## **Invitation for Bid No. 2024-061**

# Radio Shop Vehicle Lift

### **ADDENDUM No. 1**

ISSUE DATE: February 22, 2024

**Attachment: Radio Shop Lift Location Drawing**

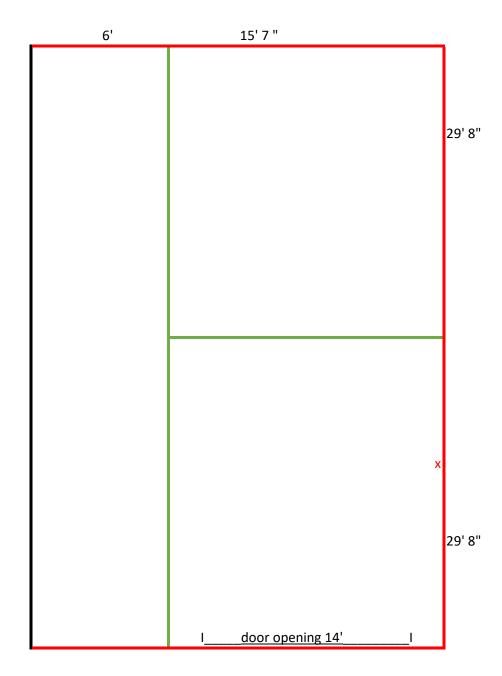
Add: Section 6 Scope of Work, 6.7 Radio Shop Lift Location Drawing Radio Shop Lift Location Drawing is attached.

**2. Question:** Could you provide a drawing/dimensions for the shop where the lift will be installed?

<u>Answer:</u> Yes, this is part of installation. The electrical panel will be located in the northeast corner of the building.

**6. Question:** There is a seam that runs the entire length of the bay on the left. Both left side posts will come into contact with the seam. Concrete work will be required. ALI (Automotive Lift Institute) lift inspection standards will require a pad to be poured for each post. Is the bidding contractor responsible for cutting, removing, tying in and pouring, finishing the required pads?

**7. Question:** Due to the wall only being 12" from the door track on the right side, the lift will be square in the bay but off center in the bay by approximately 9". Is this acceptable?

Answer: Refer to Section A) Item #1

**Answer:** Yes, this is part of the installation.

<u>Answer:</u> Locate the lift square and as close to the east wall as possible to line up with the entry garage door understanding minimal distance off center to be approachable with vehicles.
